Bid Addendum No. 3

PROJECT: The Center - Adaptive Reuse and Tenant Infill

DATE: 4/12/2023

NORTHSTAR PROJECT No. 19-022

Sheet Title: **EXITING PLAN**
 Scale: 1/8" = 1'-0"
 Status: **CONSTRUCTION DOCUMENTS**
 Drawn By: Author
 Checked By: Checker
 Date Issued: 12-01-2022
 Project No: 19-022
 Sheet No: **A012**

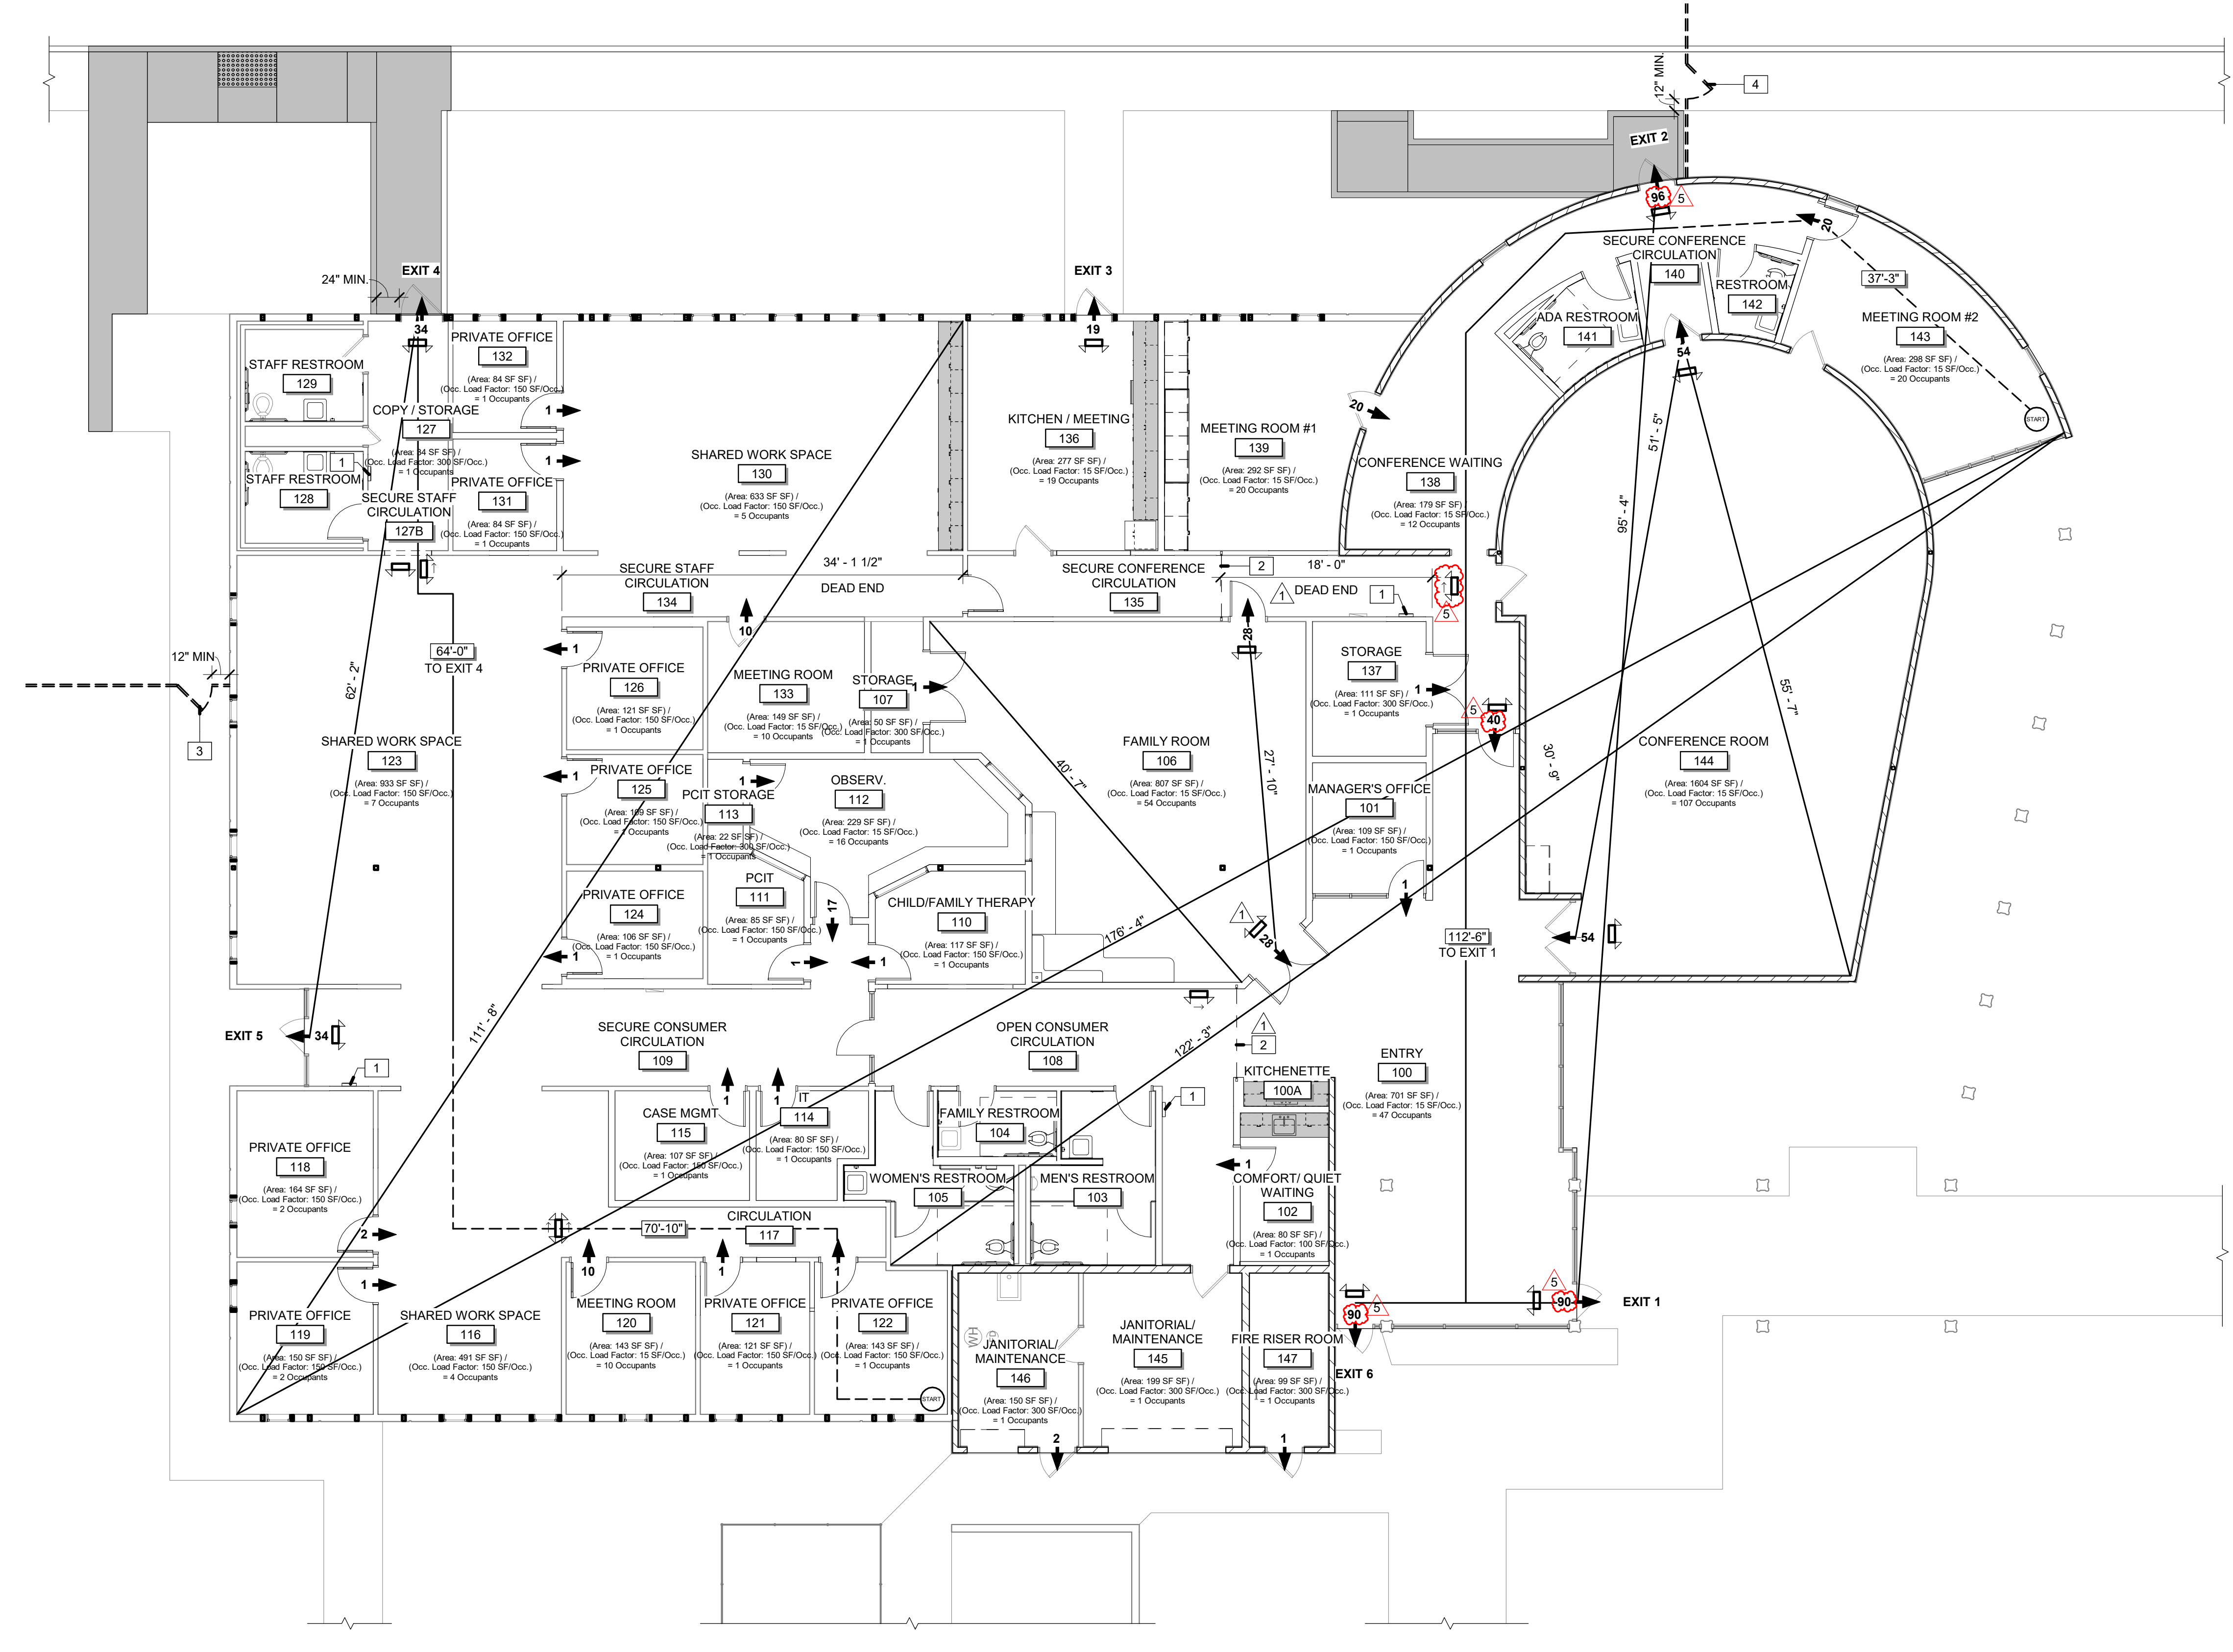
- City Plan Check Comment for room 106 exiting. Revised direction indicator for one (1) illuminated exit sign and adjusted exit occupant loads, see sheets A012 & E231.
- Door 145.B and 146.C width and height corrections, see sheet A111
